Re: 2-4 John Street and 11 Elizabeth Street Camden

DA s4.56 Modification: 2008/644/12

Staged redevelopment of the former Camden High School site comprising demolition of disused school buildings, remediation of contaminated land, earthworks, construction of 193 self-contained seniors living dwellings, a 76-bed residential care facility, a 51-bed motel, a restaurant, cultural and community centre, medical centre, 1 shop, undercroft and basement car parking and landscaping works

Table 3 – Approved and proposed building heights

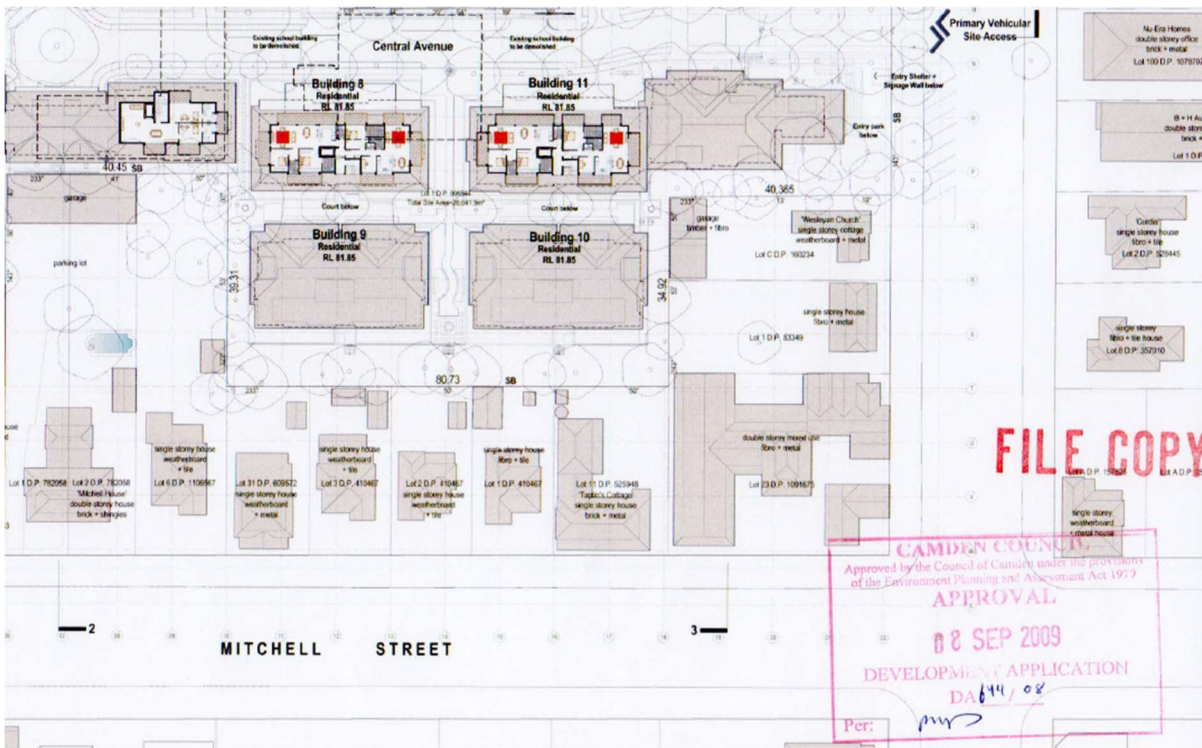
These numbers are not consistent with the “approved” heights included in the above table extracted from the Modification Planning Statement. Of course, any four -storey parts of the buildings that would be much higher again than indicated in our height estimate above.

It is very unclear why four storeys for Building 8 would be shown as 86.62 but 81.21 for Building 11. We could not find any additional information on hand about Building 8 and 11 being originally approved as four- storeys. We could be wrong, but we estimate a ridge height of 86.62 to be a tall four-storey at approximately 14m, a 100% height exceedance of the LEP standard. We find it difficult to believe that if councillors at the time had understood this that the DA would have been approved.

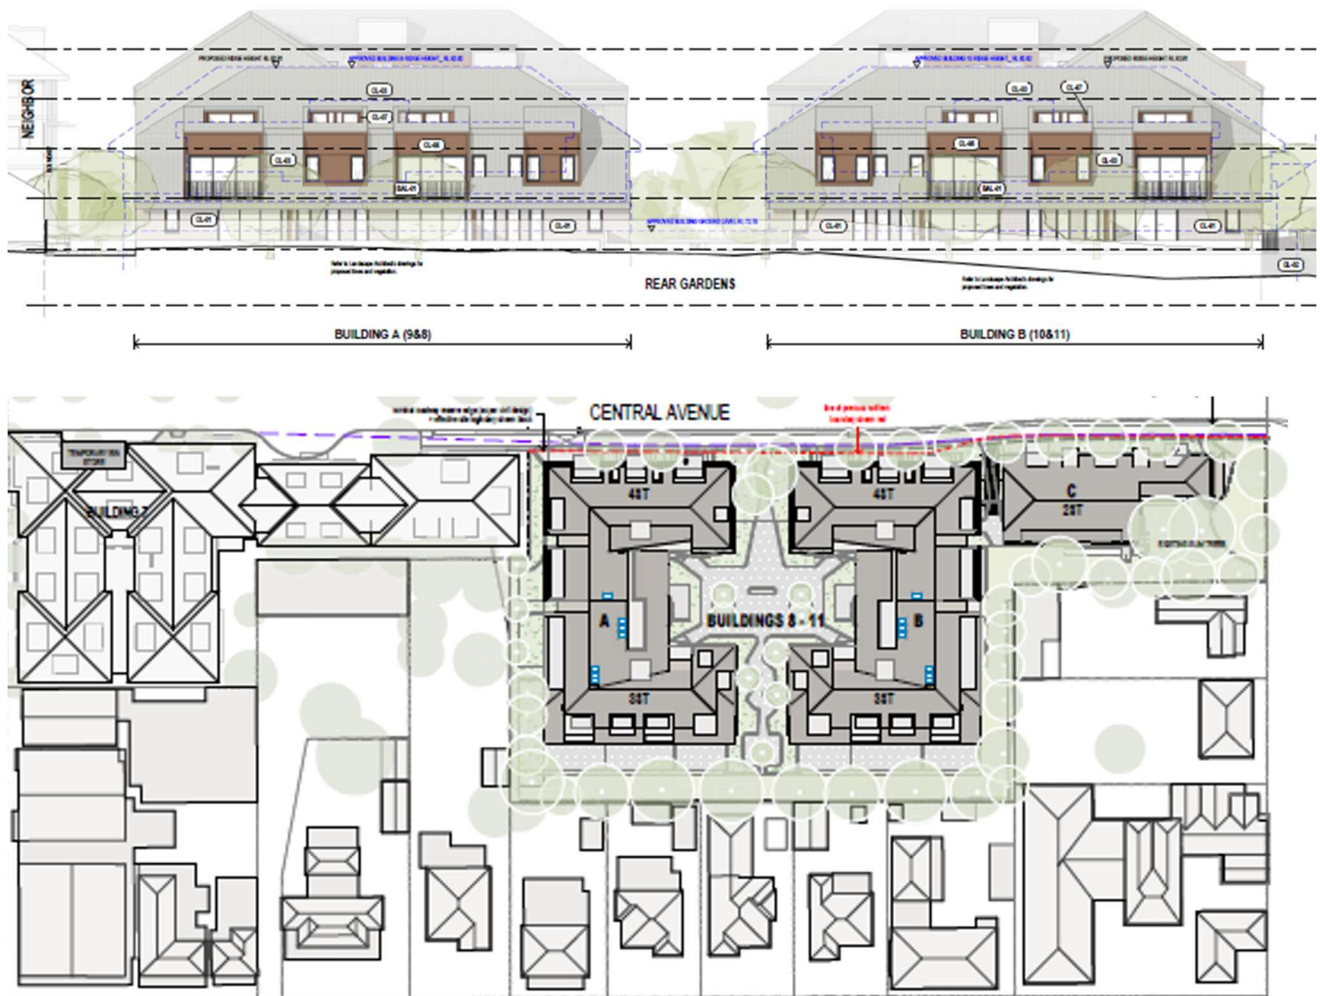
Heritage-listed Taplin Cottage is an historic low-scale building, possibly the oldest in Camden. Although specifically referred to in the justification as requiring sensitive treatment, the proposed buildings would be extremely dominant and by no stretch of the imagination be of similar height and scale.

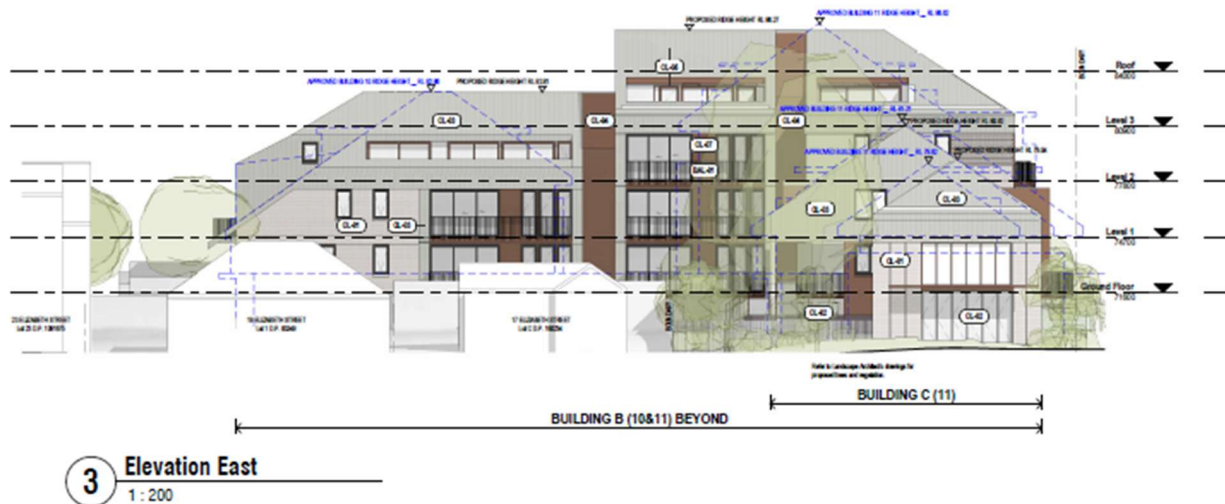
The elevation and visual impressions below tell a different story about the impact on Mitchell and Elizabeth Street cottages.

The Architectural Plans do not provide a southern elevation that shows the scale of the houses with the proposed buildings behind them, but the eastern elevation clearly shows the difference in height and scale with the heritage-listed cottages in Elizabeth Street.

The looming large edifices do not suggest privacy, visual amenity or reflect residential character as claimed.

Whilst accepting that the parts of the buildings closest to the cottages do present as two-storey with loft, they are much higher than the 7m height limit standard intended to accommodate two-storeys. They are also not fine-grained as required in the HCA under the planning instruments.

Ground Floor Landscaped Area Proposed

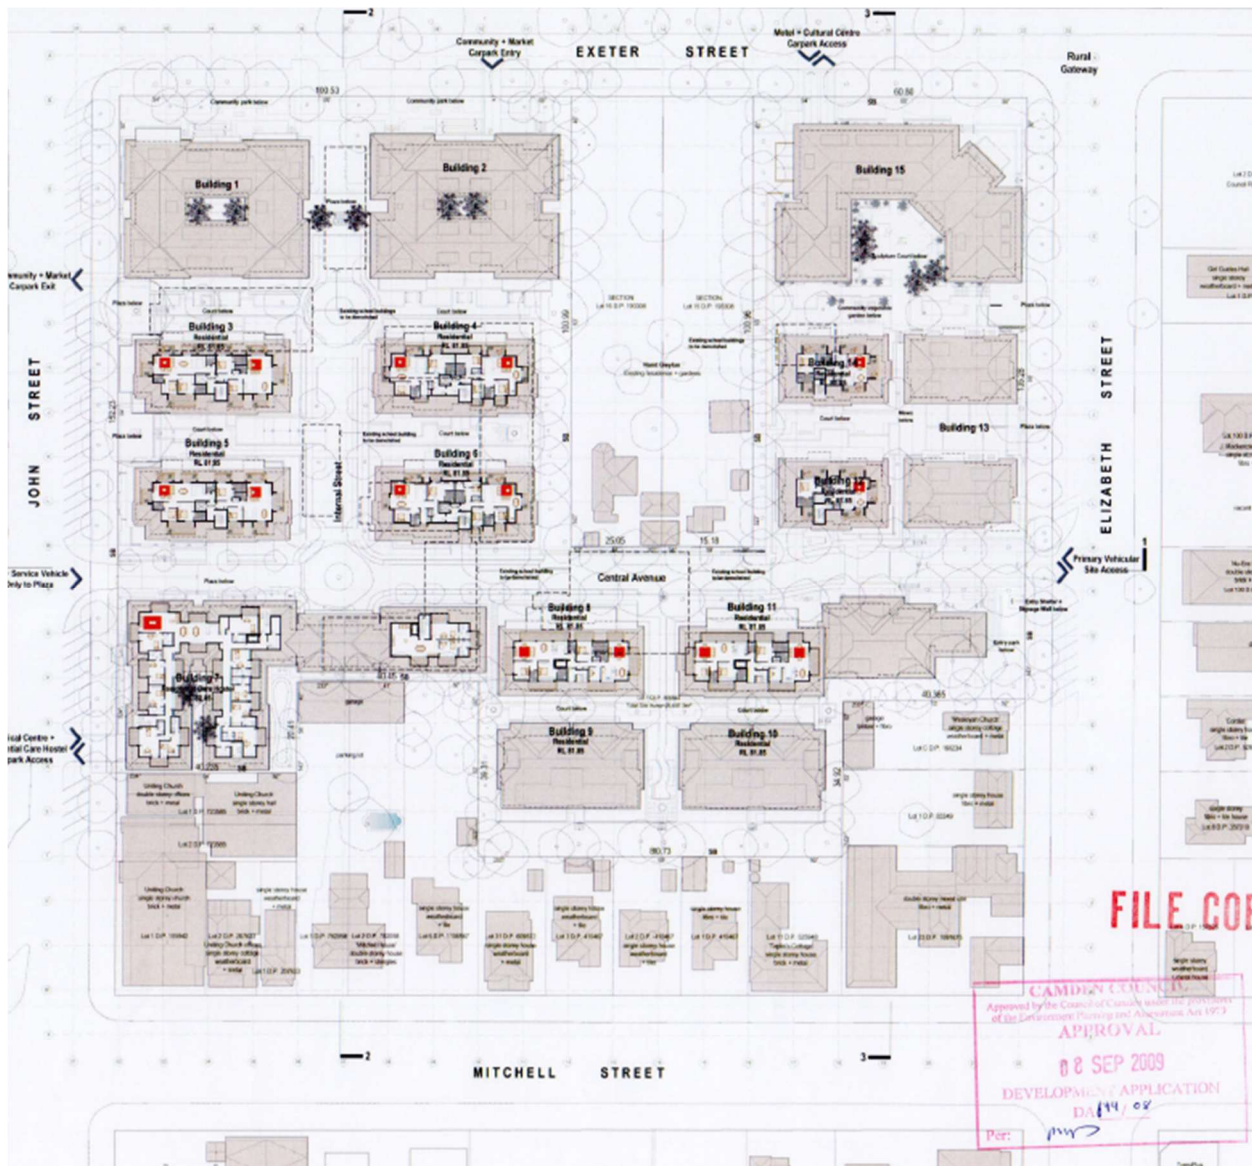
As shown below, much of the 10.975m¹⁰ ground floor setback from the properties in Mitchell Street is paved private terrace extending the living area of the buildings, leaving less for deep soil and potential vegetation screening, which would in any case take many years to reach a level that would afford much privacy or visual and acoustic amenity. Similarly, the upper floor balconies extend living space into the setback and provide what would seem to be excellent views into Mitchell Street properties. Extending living areas into the setback reduces privacy and acoustic amenity for affected residents of Mitchell and Elizabeth Streets.

The plans state that the deep soil area (shaded green) has been reduced from the approved 1154.1m² to 409.8m², although the proposed development is denser than that approved. This is not acceptable. The deep soil area, unbuilt-upon natural ground, is more important the denser the development. It allows for the planting of large trees and the infiltration of rainwater, urban cooling, and maintaining local amenity, all considered very significant for environmental sustainability.

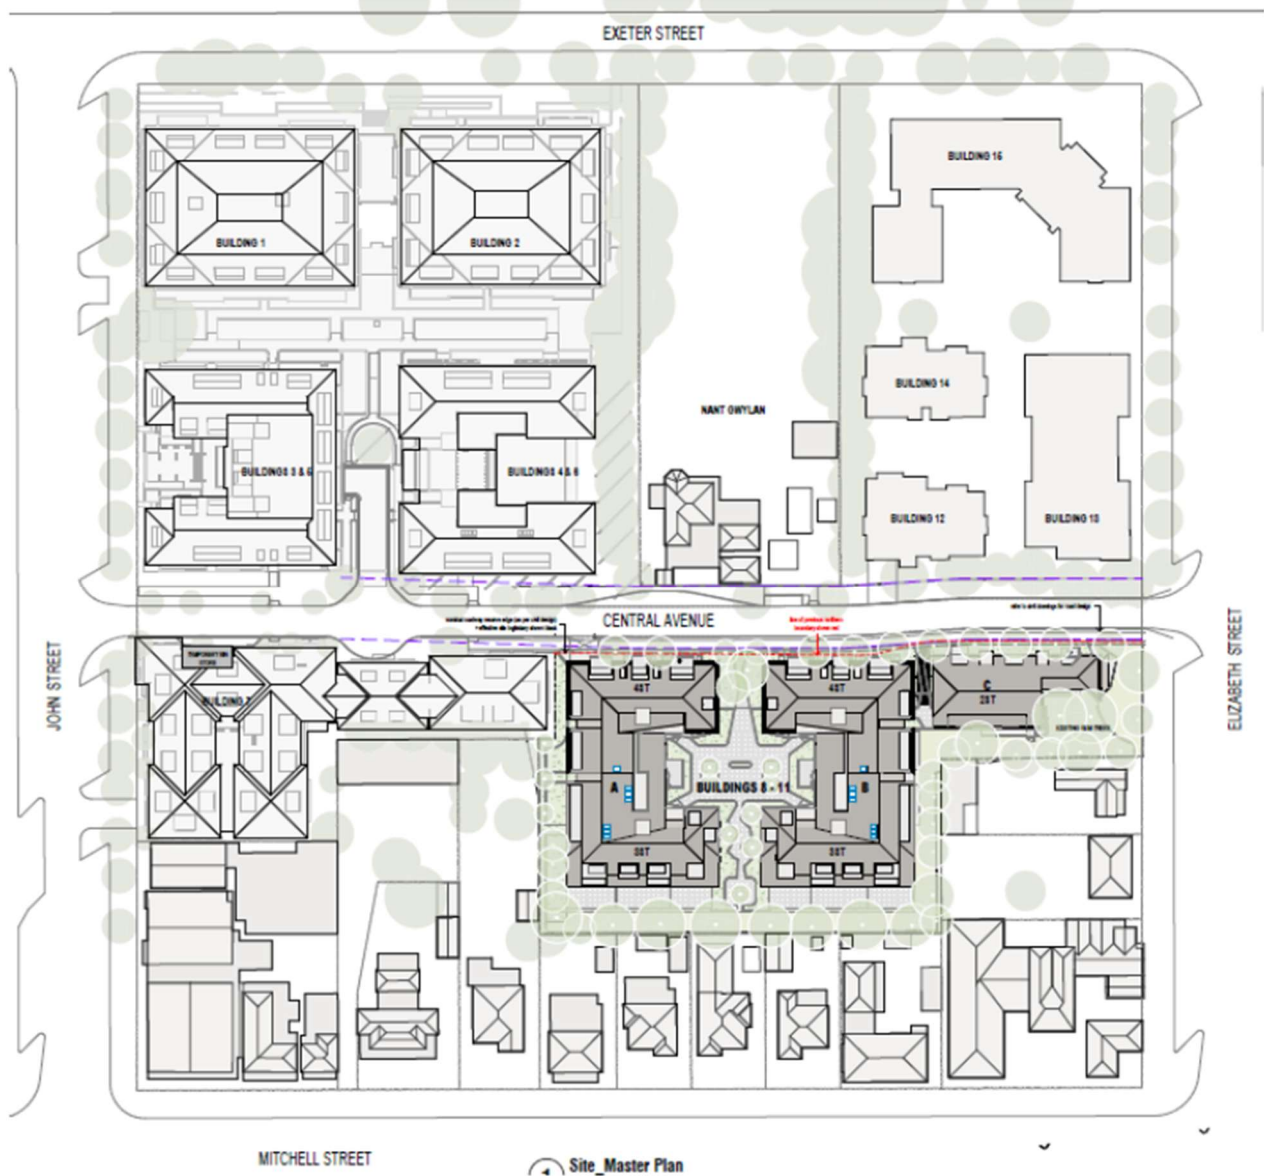
The original site plan shows smaller building footprints and more openness than the 2025 site plan which includes the 5th modification to consolidate Buildings 3 and 5, the 9th modification to consolidate Buildings 4 and 6 as well as this 12th modification proposal involving reconfiguration and consolidation of four buildings into three.

The comparison between what was approved and what is now on the table shows a marked increase in building density on site making the development configuration more urban and not at all reflective of the town’s original and unique country character as promised in the original Assessment Report. With so many modifications, the original concept has been lost and modification would seem to no longer even pay lip service to compatibility with the human scale fabric of the town. This represents a breach of faith with the community which trusted the planning process.
